SUPPLEMENTARY ASSESSMENT MEMORANDUM

Panel Reference	PPSNTH-80
DA Number	DA2021/056
LGA	Nambucca Valley Council
Proposed Development	Seniors Housing (271 Self-contained dwellings, 75 bed care facility, and recreation facilities)
Street Address	24 Coronation Road, Congarinni North Lots:155 and 188 in DP: 755537 and Part Lot: 1 DP: 1000618 and Part Lot: 2 DP: 1265232
Date of Report	23 November 2021

FIGURE 1 - Flood Hazard Classifications

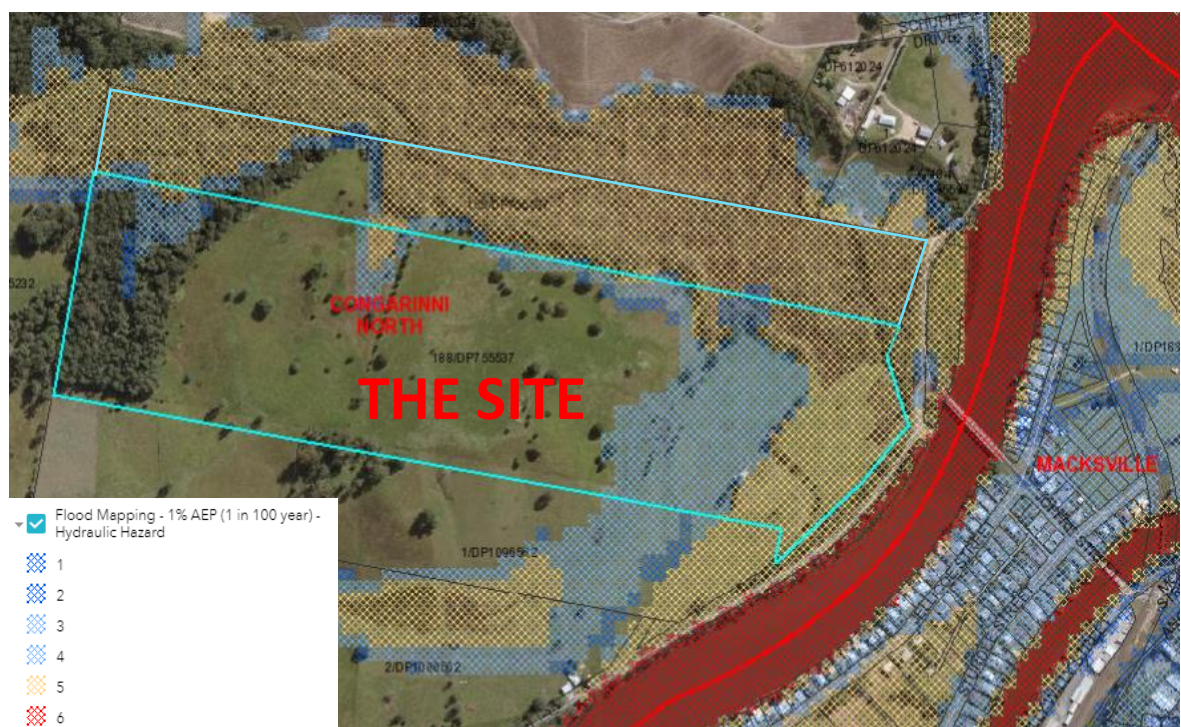
7.0 *Finally, having read the information provided by Council the Panel member considers that the issue of ‘shelter in place’ is a key issue for this DA. The Panel member understands that there was a previous Catholic School DA in Macksville where the same issue was pivotal – the DA was refused by the Panel and the refusal later upheld in Court. The Panel member can’t see a reference to any Council DCP or Policy in relation to Shelter in Place which may have been considered subsequently – perhaps that could be clarified too?*

Following the refusal of the Dudley Street School (DA2010/234) Council adopted a Flood Risk Management Plan (2017) which is based upon the 2015 modelling. Under the Flood Risk Management Plan the subject site is includes land within the H2 – H6 Flood Hazard Classification areas the parts of the site affected by the various Flood Hazard Classifications are shown in **Figure 1**.

The Matrix indicates that Critical Uses and Sensitive Uses are unsuitable land uses within the Flood Hazard Classification areas of H5 – H6 and that Critical Uses are also unsuitable land uses within the H2 – H4 Flood Hazard Classification areas.

In summary, under the Flood Risk Matrix the areas subject to the H2- H5 hazard classification are unsuitable for the proposed development. The proposed development can provide access to land located above the PMF, however the only means of evacuation from the site is via helicopter.

The proposed development is inconsistent with Councils Flood Risk Matrix, specifically the risk associated with evacuation.
